**Minutes of the North Carolina Building Code Council**  
**September 10, 2012**  
**Raleigh, NC**

**Item B – 2 Request by Daniel J. Walker, PE, with the Metal Building Manufacturers Association, to amend the 2012 NC Energy Code, Tables 502.1.2, 502.2(1), and 502.2(2), and Appendix 2.2. The proposed amendment is as follows:**

SECTION VIEW OF METAL FRAME ROOF:  
FILLED CAVITY FIBERGLASS INSULATION

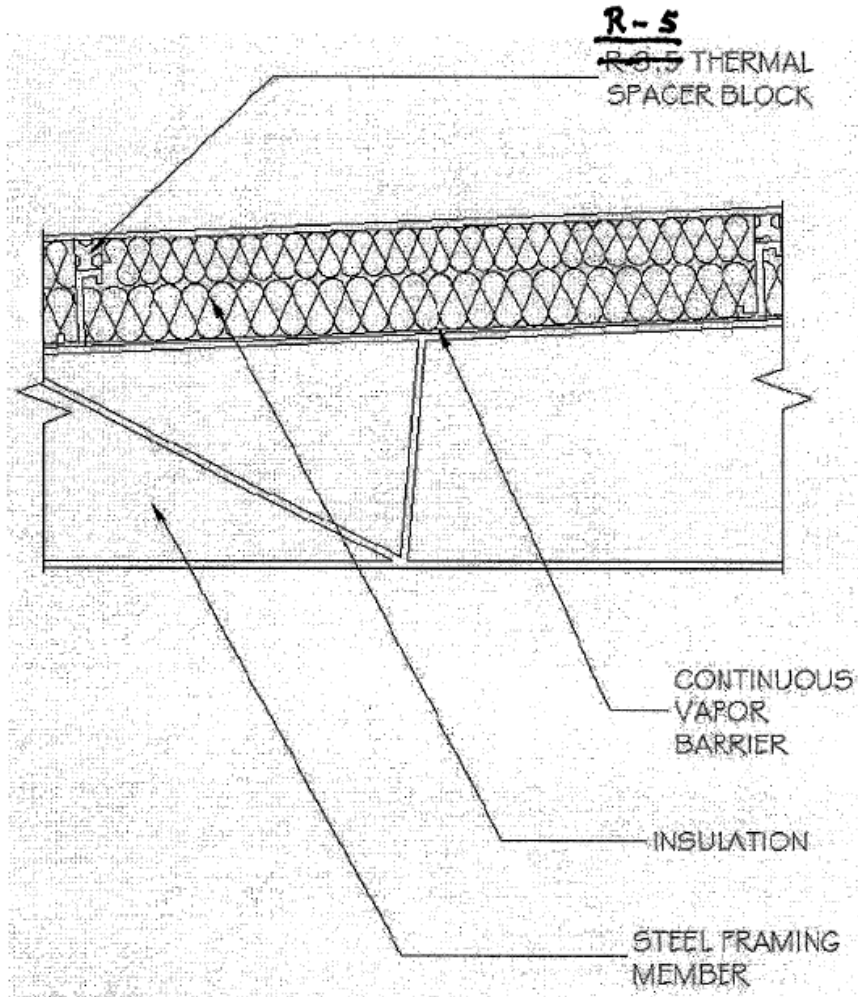
<b>ROOFS</b>	<b>DESCRIPTION</b>
R- <del>11</del> 10 + R-19 FC	Filled cavity fiberglass insulation. A continuous vapor barrier is installed below the purlins and uninterrupted by framing members. Both layers of uncompressed, unfaced fiberglass insulation rest on top of the vapor barrier and are installed parallel, between the purlins. A minimum R-3.5 thermal spacer block is placed above the purlin/batt, and the roof deck is secured to the purlins. Drawings of typical details are shown in Appendix 2.2.

Revise Appendix 2.2 as follows:

Motion/Second/Granted. The request was granted unanimously.
